**Re: Project, Permit No. M-1980-244;  
Third Adequacy Review, Amendment Application (AM-13) Response to Comments**

## THIRD ADEQUACY REVIEW COMMENTS AND RESPONSES

FILENAME: 0106.033.039P  
 DRAWING NO.: A14  
 REVISION: 2

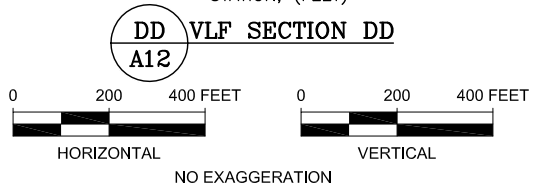
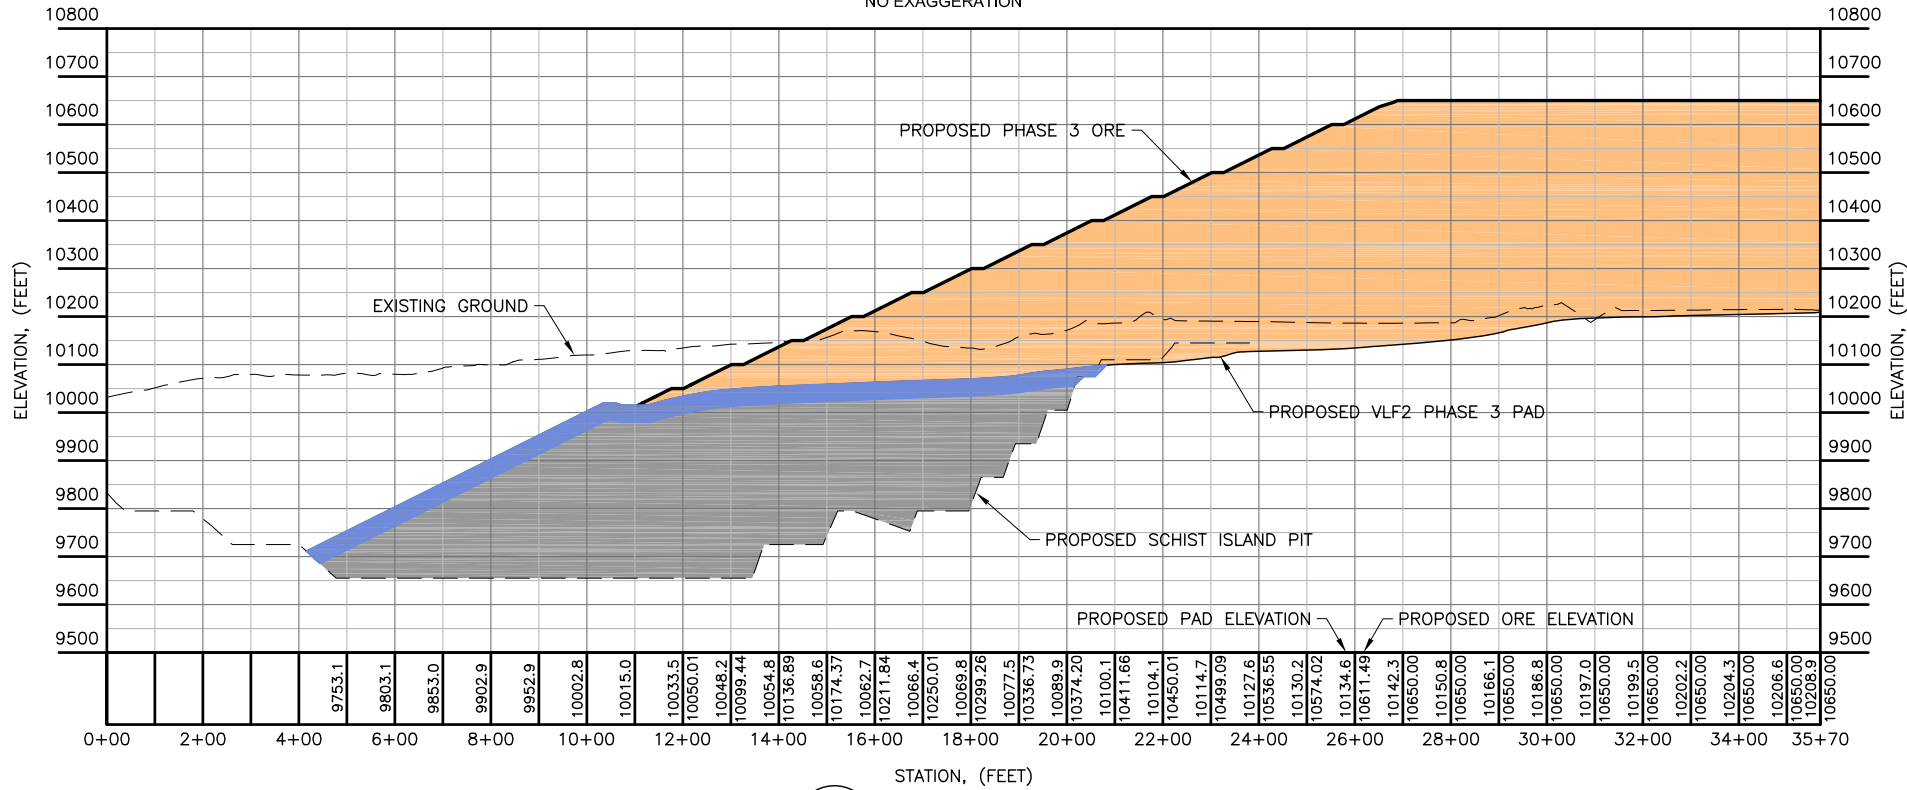
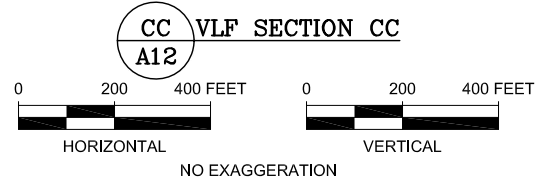
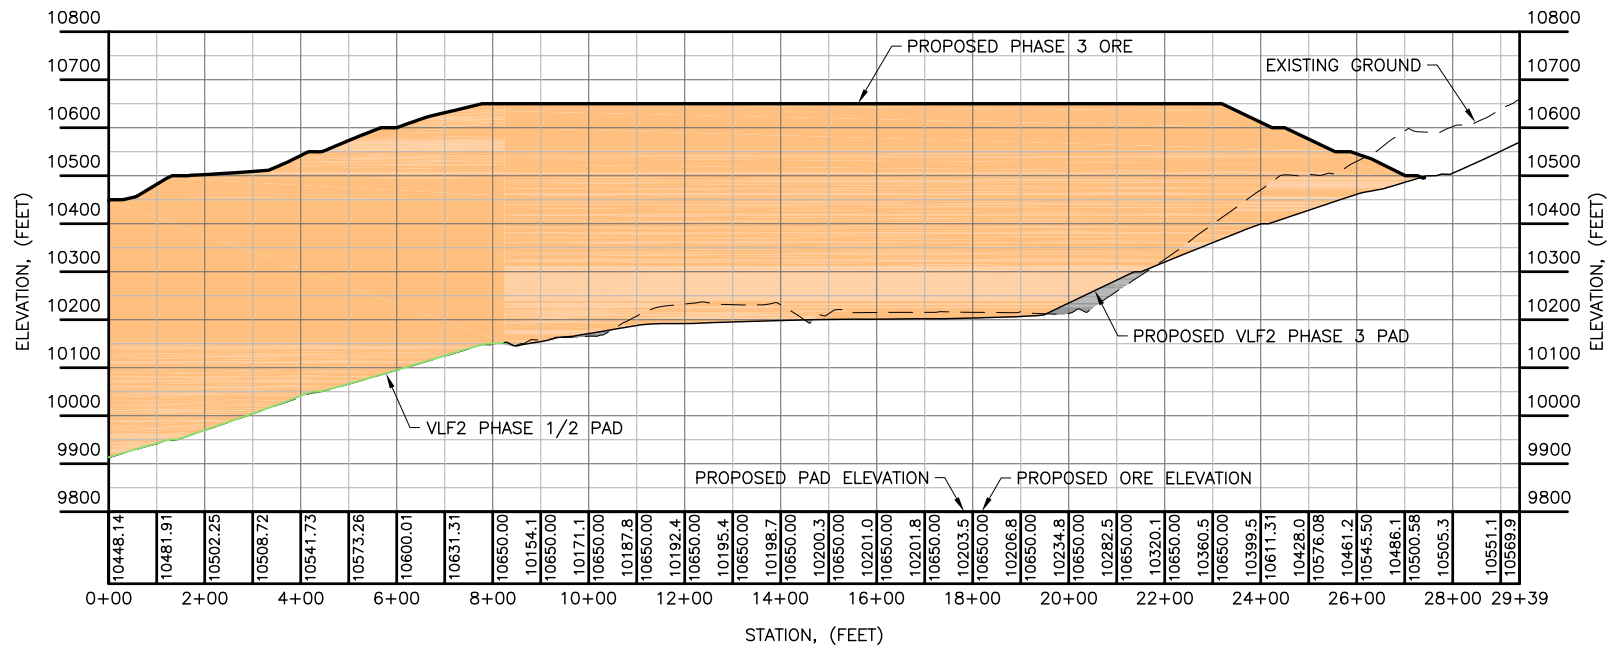
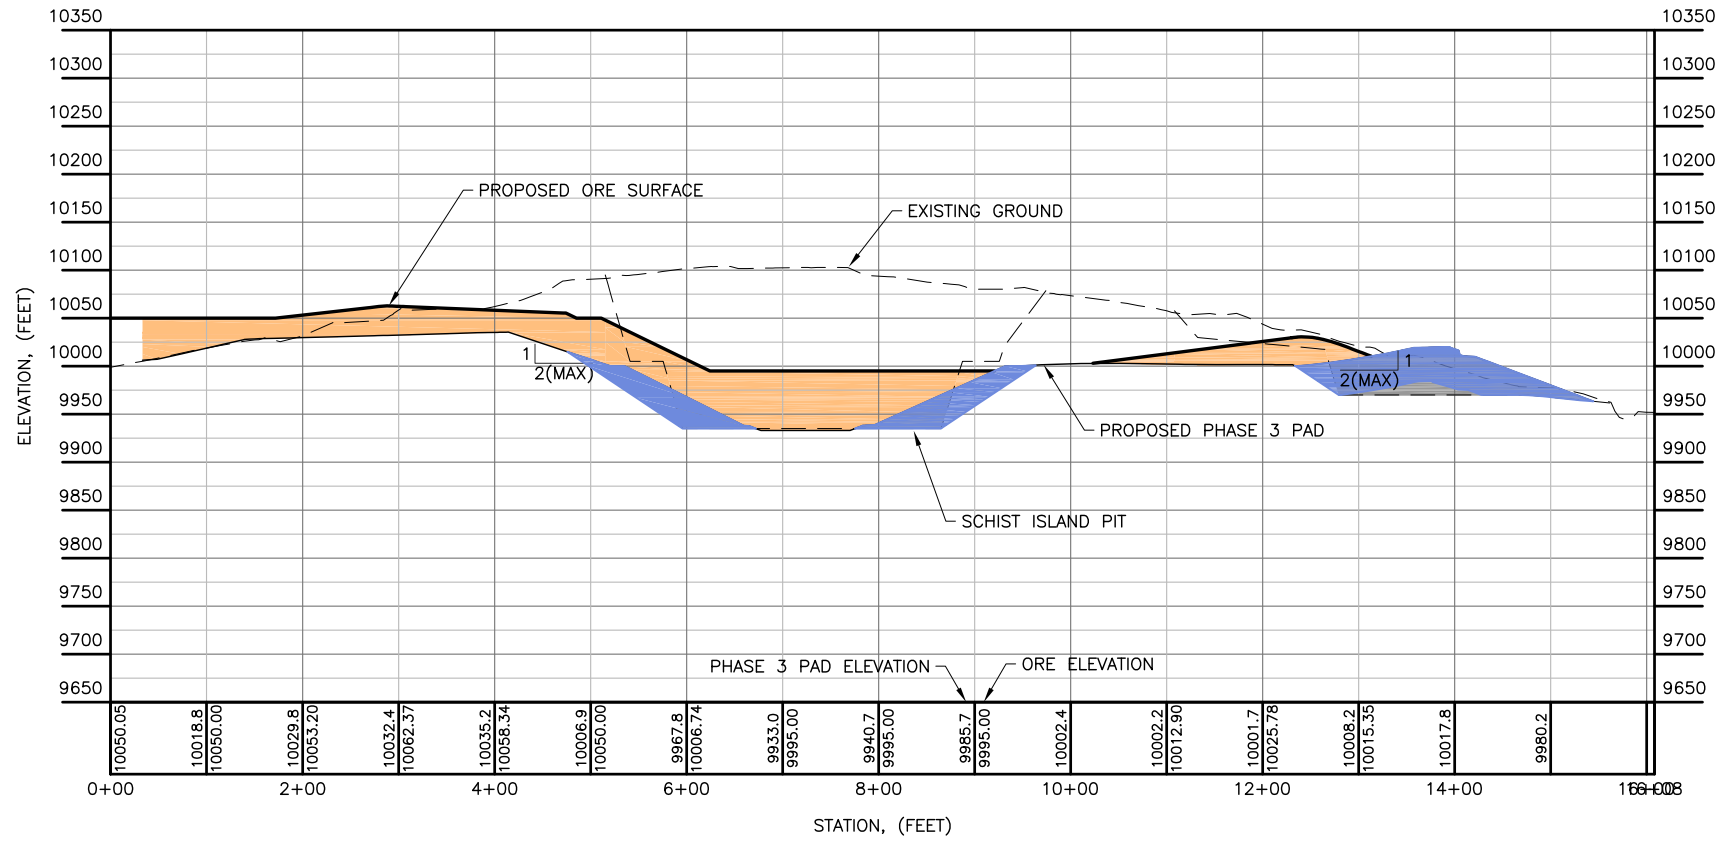
*VL2 Phase III Design Drawings A-13, A-14, A-19 and A-20. No formal comment issued. As discussed during a 21 December conference call with CC&V. Please update Drawings A13, A14, A19, and A20 to include additional detail specifying ore, structural fill, and overburden fill material.*

During a 21 December teleconference call with Division representatives, the Division indicated to CC&V that design Drawings A13, A14, A19, and A20 should be updated to reflect the different materials that would be used for pit backfill per the specifications and intent of the design. CC&V has updated those design drawings to show overburden backfill and structural fill materials that will be used to construct the pit backfill. The updated drawings are enclosed in Attachment 7.
